Application Ref: 18F/1035

Land to the west of St Bartholomew Road, south of Oriel Street and north of Naylor Street, Liverpool,

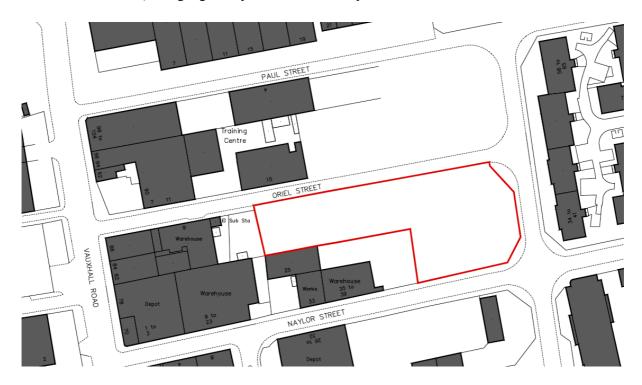
You are aware that, since the submission of the application, my client has been in discussion with various prospective purchasers, one of which wishes to purchase the land to the south of Oriel Street (but not the land on the north side) as highlighted by the red line on the plan below.

That said, my client is now looking to reduce the current application to cover **only** the land on the **south** side of Oriel Street (as per the red line above). A separate "Phase 2" planning application will shortly be submitted for the proposal on the north side of Oriel Street.
